RESPONSE TO NRCAN-04

ID:	NRCAN-04
Expert Department or Group:	Natural Resources Canada
Guideline Reference:	7.1.5 Project Setting and Baseline Conditions – Groundwater and Surface Water
EIS Reference:	Baseline Study Appendices 3, Attachment 3-D, Hydrogeology Baseline Report, Sections 3.2, 4.3. Chapter 6, Appendix 6A, Section 3.3, Appendix 2C Prefeasibility Geotechnical Report, Section 7.4
Context and Rationale:	<p>The EIS Guidelines state that the EIS will present information in sufficient detail to enable the identification of how the project could affect the Valued Components and the analysis of those effects.</p> <p>Hydraulic conductivity in the overburden was assessed through single well response tests. The majority of these tests were completed in wells that were screened across the bedrock-overburden interface. A review of these tests indicate increased hydraulic conductivity with increased proportion of the screen within the bedrock (Section 4.3 of BSA 3D). These results, combined with the noted lower rock quality designation within the upper 5-10m of bedrock, appear to support a conceptualization of an upper, more permeable bedrock zone within the top 5-10m.</p> <p>Within

Figure 17 Hydraulic conductivity vs Depth by Rock Type and Structural Feature for (a) Marathon deposit, and (b) Leprechaun deposit

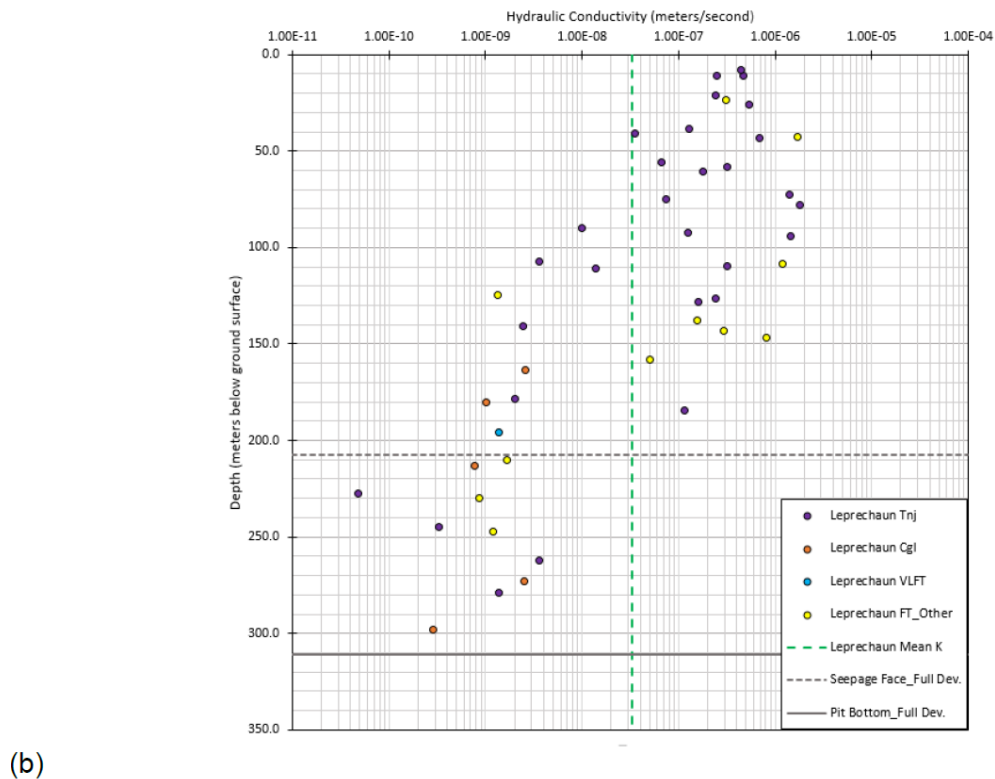
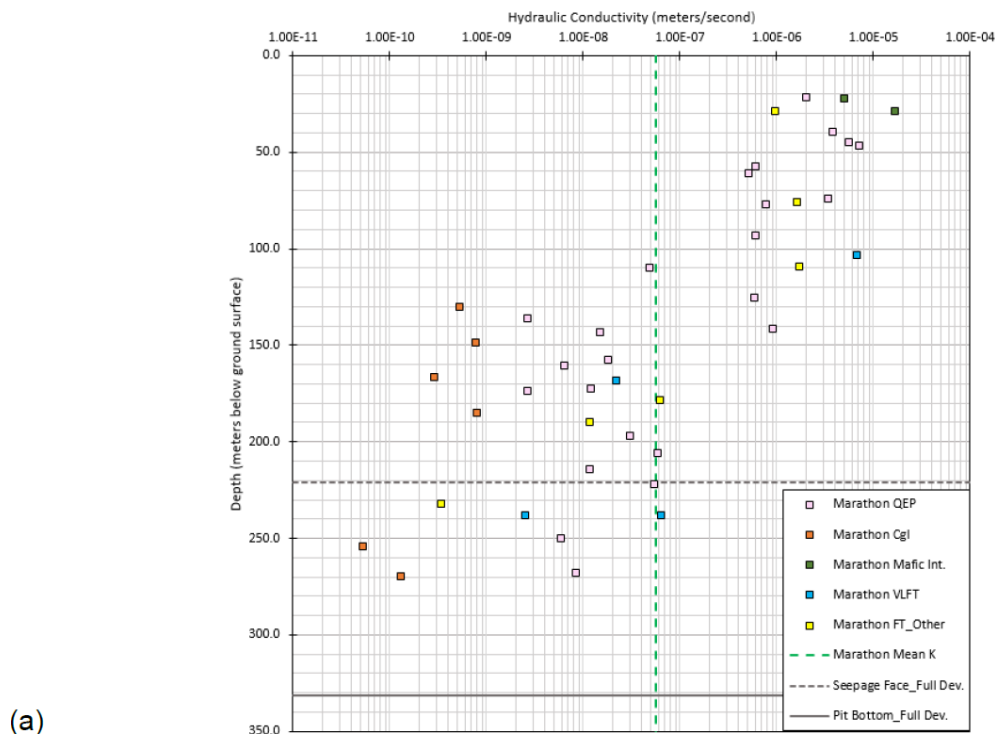
ID:	NRCAN-04
	<p>these wells through testing. Results at these three wells may underestimate shallow bedrock hydraulic conductivity.</p> <p>Hydrostratigraphy implemented within the groundwater flow model is the main factor that controls the assessment of groundwater flow quantity and direction.</p> <p>Hydrostratigraphy should represent field observations to the extent possible. Failure to represent a conductive upper bedrock unit may result in an incorrect assessment of changes to surface water quantity and quality, which would be carried forward to the assessment of fish and fish habitat.</p>
Information Request:	<ol style="list-style-type: none"> a. Update the geological and groundwater models to represent the observed hydrostratigraphy and measured hydraulic conductivity variations with depth. Implement variations in bedrock hydraulic conductivity with depth, only to the extent supported by hydraulic testing and rock quality designation. b. Reevaluate the single well response tests at MW5, MW6, and MW8 to determine if there is sufficient displacement and evaluate the potential for enhanced well development through the testing process. Update the conceptual model and parameterization as needed.

Response:	<ol style="list-style-type: none"> a. The geological and groundwater models presented in the EIS represent the observed hydrostratigraphy and measured hydraulic conductivity variations with depth. Further to the data used to support the models presented in the EIS, the results of additional packer testing completed in the area of the open pits are presented on Figure 17 (Terrane 2021). These plots indicate a decreasing trend of hydraulic conductivity with depth in the bedrock, which is consistent with the interpreted distribution of hydraulic conductivity in the shallow, intermediate, and deep bedrock units at the site. <p>Also, additional hydraulic conductivity tests were completed in the shallow bedrock and overburden following submission of the EIS (Gemtec 2021) and are presented on Figure NRCAN-04.1. These tests are generally limited to depths of less than 30 m below ground surface. As shown on NRCAN-04.1, the hydraulic conductivity within the top 30 m from ground surface (or 20 to 25 m below top of bedrock) show a varied range of hydraulic conductivity from 1×10^{-7} m/s to 1×10^{-4} m/s. These data are consistent with those used to develop the geological and groundwater models presented in the EIS.</p> <p>The hydrostratigraphy used in the development of the geological and groundwater models presented in the EIS has been reviewed is considered appropriate, and this has been confirmed by additional data collected since completion of those models. Therefore, the geological</p>
